LEONE & SONS AMENDED SITE PLAN (94-15) ROUTE 32

**TOWN OF NEW WINDSOR
PLANNING BOARD
REVIEW COMMENTS**

REVIEW NAME: LEONE SITE PLAN AMENDMENT
PROJECT LOCATION: NYS ROUTE 32 (EAST SIDE)
SECTION 45-BLOCK 1-LOT 1.22
PROJECT NUMBER: 94-15
DATE: 13 JULY 1994
DESCRIPTION: THE APPLICATION INVOLVES A PROPOSED AMENDMENT
TO THE PREVIOUSLY APPROVED SITE PLAN NO. 92-40.
THE PLAN WAS PREVIOUSLY REVIEWED AT THE
22 JUNE 1994 PLANNING BOARD MEETING.

PAUL V. CUOMO, P.E. & ASSOC.
STEWART INTERNATIONAL AIRPORT, NEW WINDSOR, N.Y. (914) 567-0063
PROJECT TITLE: SITE PLAN AMENDMENT FOR LIGHTING AND DECK
LEONE & SONS
CENTRAL VALLEY N.Y.

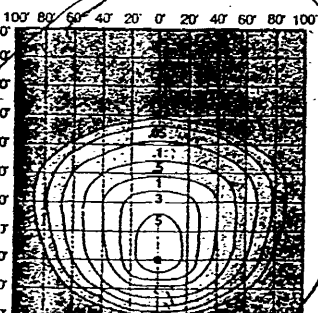
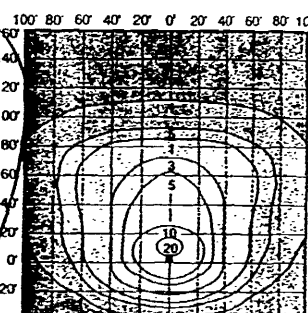
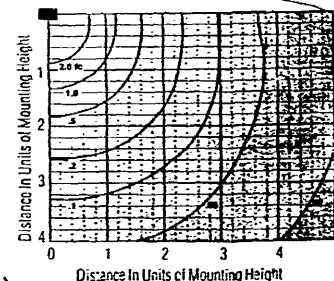
2. I have again been provided with a xerox copy of Isolux curves, portions of which are off the xeroxed copy and unusable. It is unclear to me exactly what light fixture is currently installed at the rear of the building. Further, there appears to be an error in the Isolux data as depicted for the side lights. In addition, the front light pole Isolux on the plan does not appear to coincide with the information on the xerox data sheet.

Based on a review of the site plan submitted, there appears to be insufficient lighting immediately in front of the existing retail building, with this area being a critical area since this is the location of the handicapped parking spaces.

Based on the above, it is my opinion that the lighting information provided is unacceptable. If the Board believes that an accurate lighting plan is not required for this site, then I believe they can accept the site plan amendment without the need for further submissions. If the Board believes an accurate lighting plan is necessary for this application, then I would suggest that the Applicant prepare the proper information as previously requested, and review same at the next Technical Work Session. The Applicant should not return to the Planning Board until this technical issue is resolved, utilizing the Technical Work Shop process, as it is intended.

SP-1
SHEET 1 OF 1

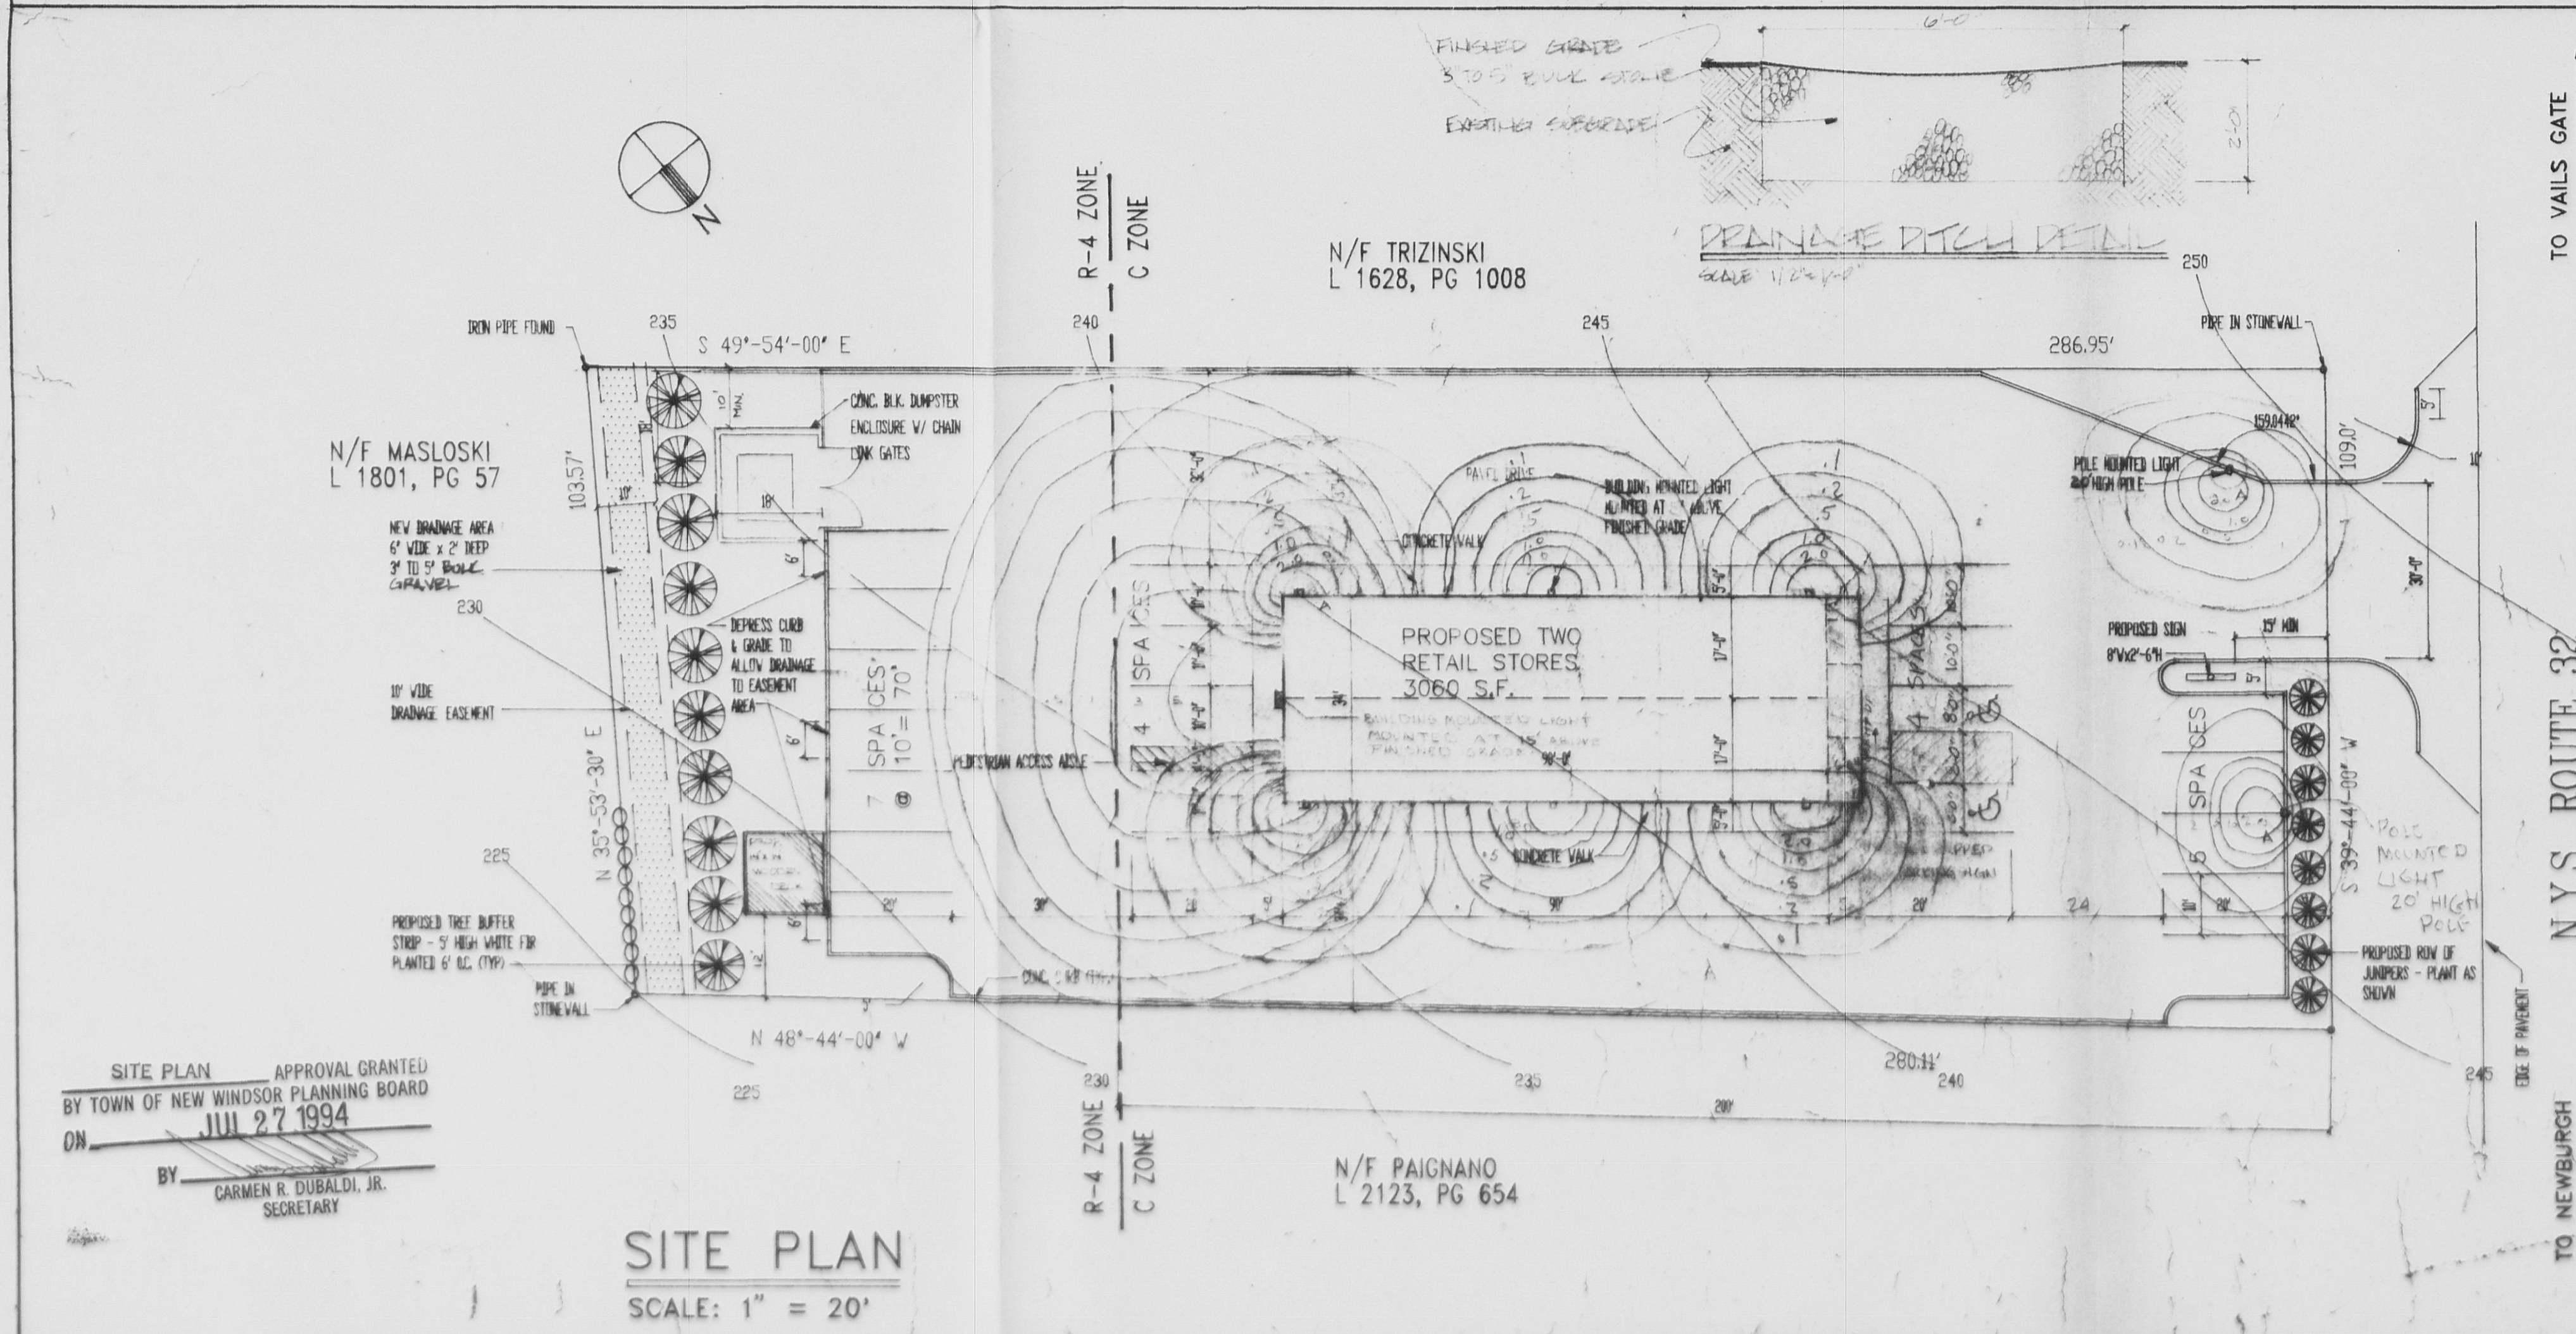
MR. EDSALL: The fixtures, isolux curves on the plan don't seem to match my understanding of what was submitted. If in fact the lighting is adequate out front, then the plan doesn't match what's happening because this shows that there's a significant deficiency in front of the building. So I don't think this--

MR. EDSALL: Yes, there seems to show lighting that the applicant told us he was not planning to install and for the lighting that has been installed, they are showing ten foot poles and I would swear they are a heck of a lot more than 20 feet that is out there. I don't think that this plan matches what's proposed or what's out there already.

MR. EDSALL: The other two that are shown on the corner of the building he told us he was not going to put in the lights that are in the front of the building are shown ten foot and I believe they are over 20 foot. So I think you really need a real plan, if you have a serious intent to review lighting on site plans, I think you should have accurate information.

MR. EDSALL: I think you need a plan. Allegedly, there's been changes in the fixtures themselves and changes in the height but some of the isolux curves are identical to what was on the other plan.

1. The layout of the completed work appears to generally comply with the plan stamped approved by the Planning Board on 9 December 1992.
2. The lighting as installed on the building and at the rear of the site varies from that shown on the approved plan. Specifically, the two rear pole lights have not been installed and the lighting shown on the corners of the building are actually located somewhat interior to the sides of the building. In addition, an additional light fixture has been installed below the peak of the building at the rear gable end. The representatives on site were advised of this discrepancy in the installation and were advised to either comply with the plan or provide a new lighting layout for review.

3. Although possibly not a problem, the front two (2) pole lights were noted as substantially exceeding the 10' height indicated on the plan.
4. The row of plantings at the rear of the site are not 5' white fur plantings, as shown on the plan. This planting row should be installed as per the approved plan.

MR. EDSALL: Just for the record, you should include that your decision relative to the changes in the lighting are based on field review and other information that you are not accepting the plan because this plan does not reflect what's out there.

- Change title to S/P Am
- add scope - 1) change outdoor ltr 2) wooden deck 3) all other per approval
- provide light cuts to diff
- remove wrong isolux curves.
